City of Neenah
Plan Commission Agenda
Tuesday, June 23, 2026 at 4:00 PM
Neenah City Hall – 211 Walnut Street
Hauser Room

RE: Site Plan #4-26 - 150 N Green Bay Road - Building Addition Site Plan - Minor Review () Status Approved

Plan Review Comments

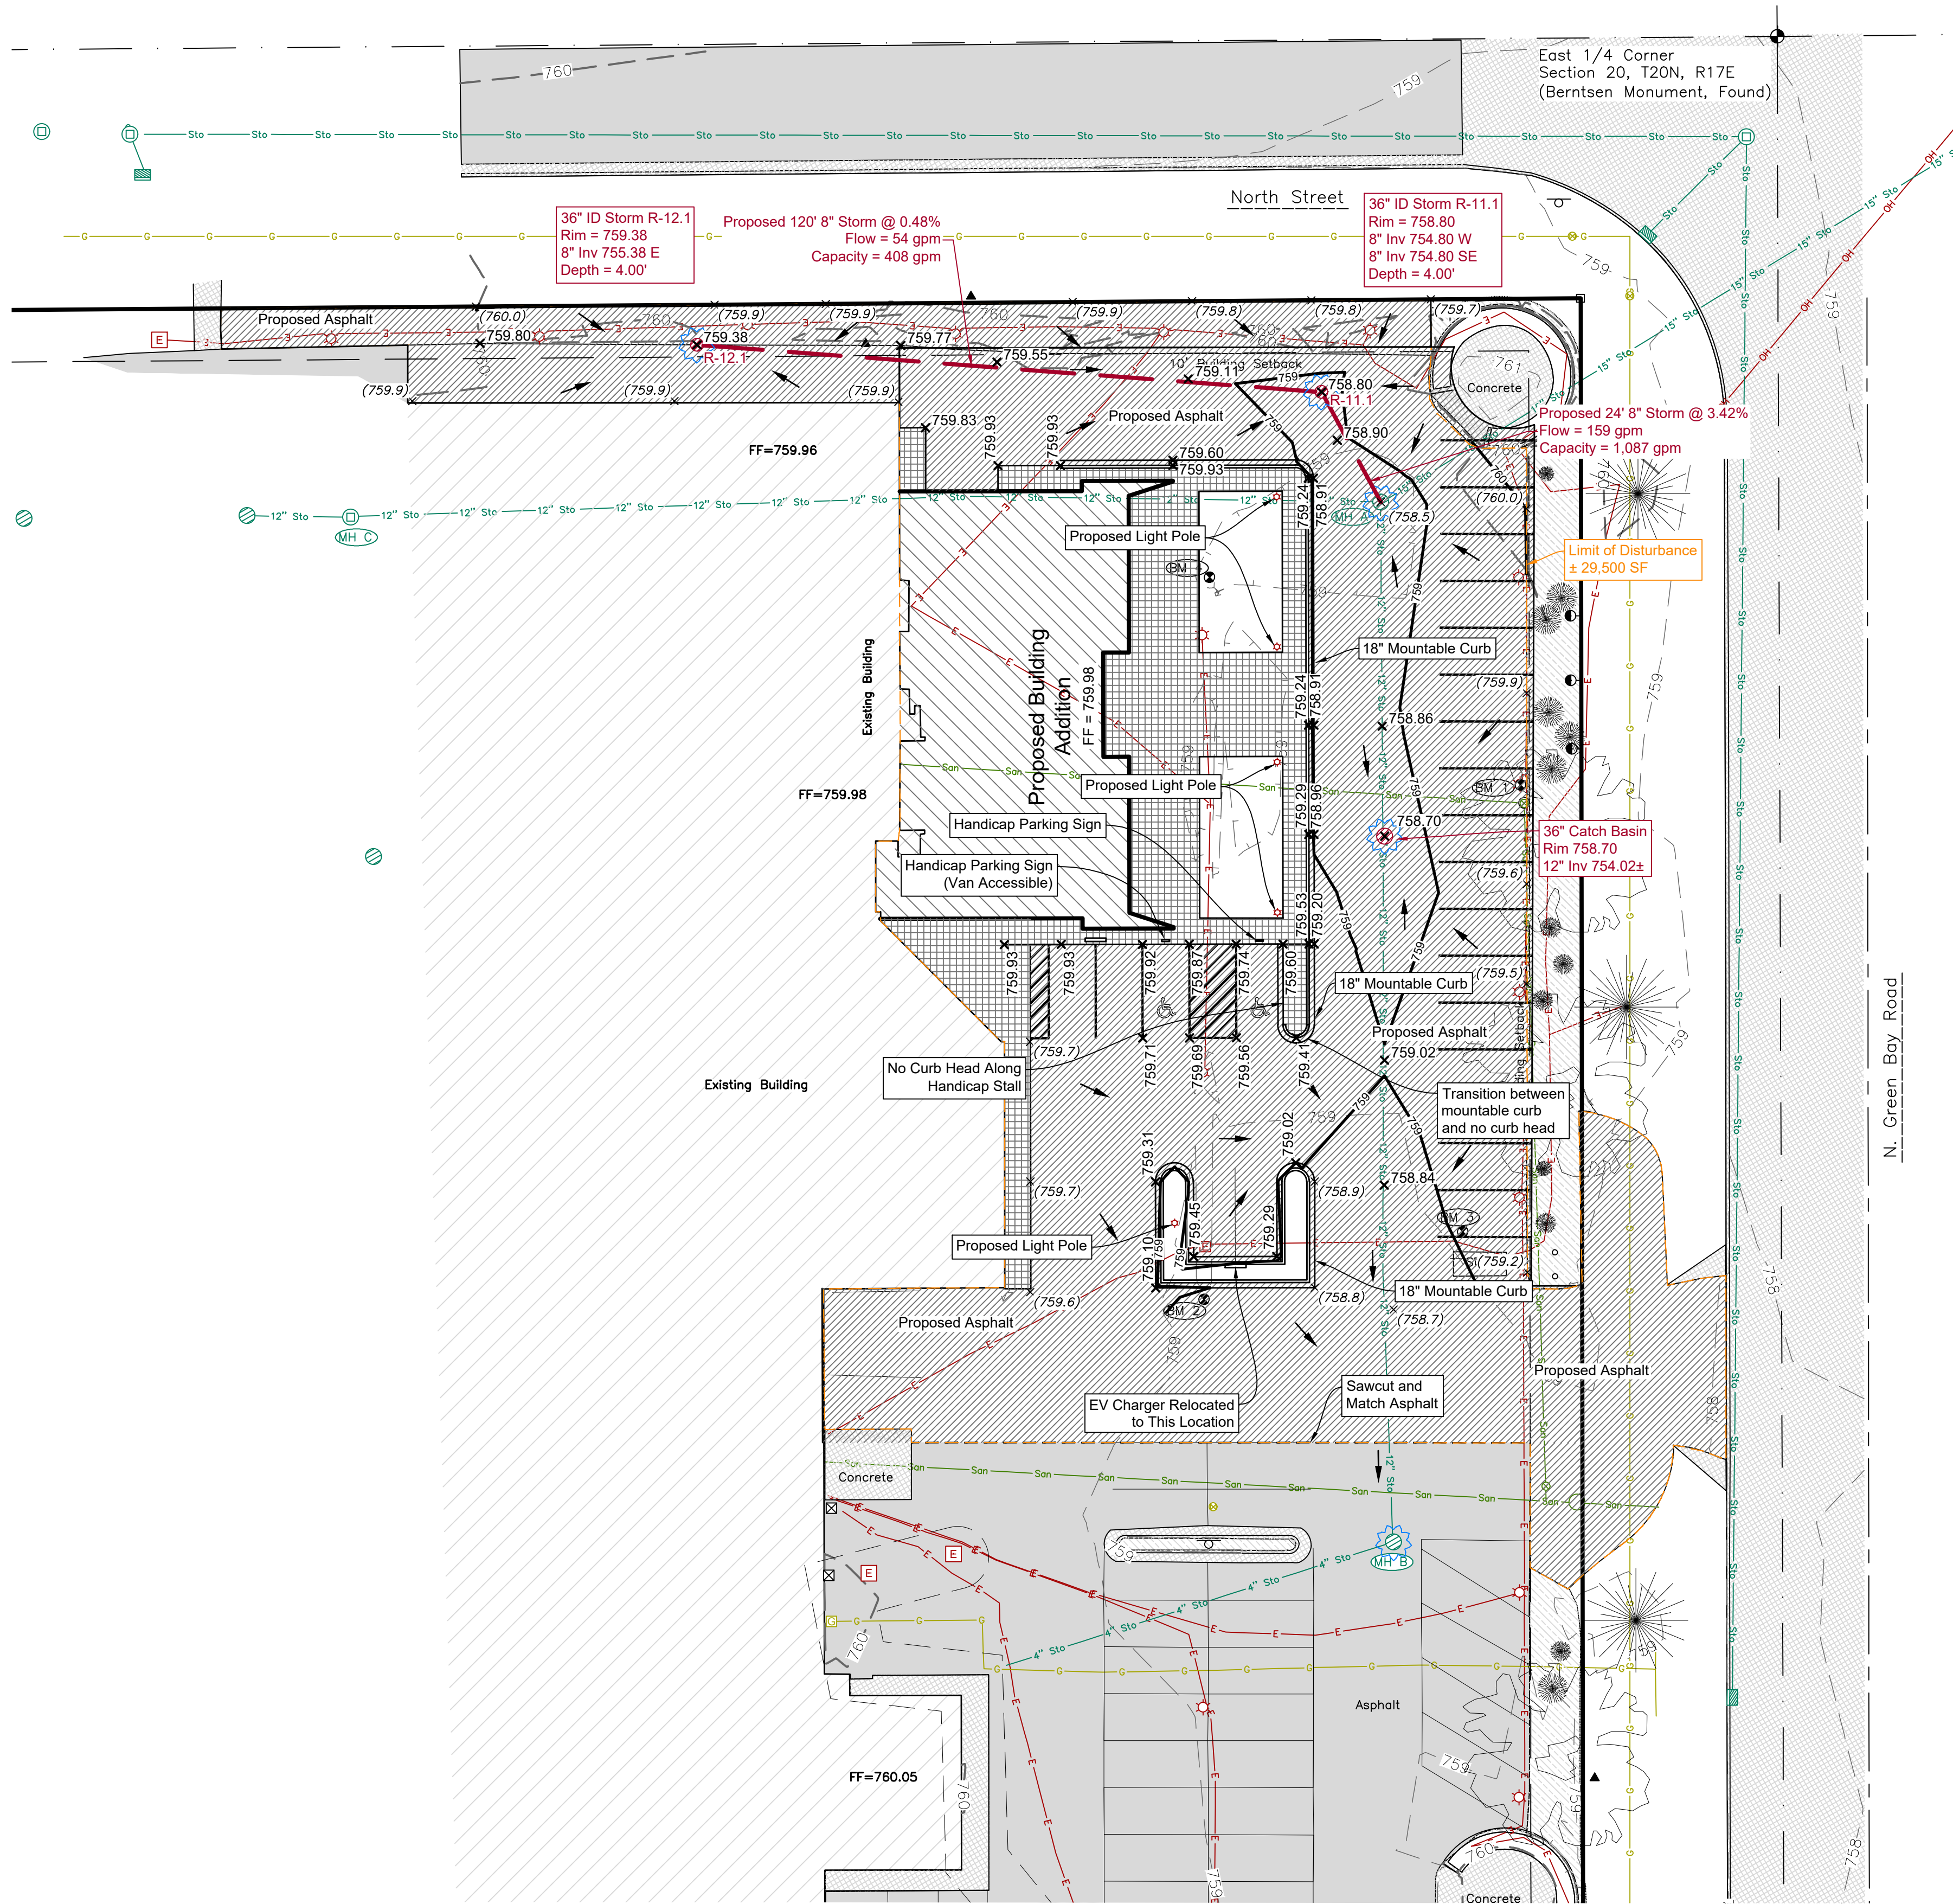
1. Prior to construction, a building permit is required. Please submit an application for a building permit online by visiting the following link: <https://evolvepublic.neenahwi.gov/>
2. Parking of vehicles between the north side of the building and the north property line along North Street is prohibited.
3. Changes to the site plan may require additional review. If you make any changes to the site plan after Plan Commission review, please submit those changes to the Community Development Department.
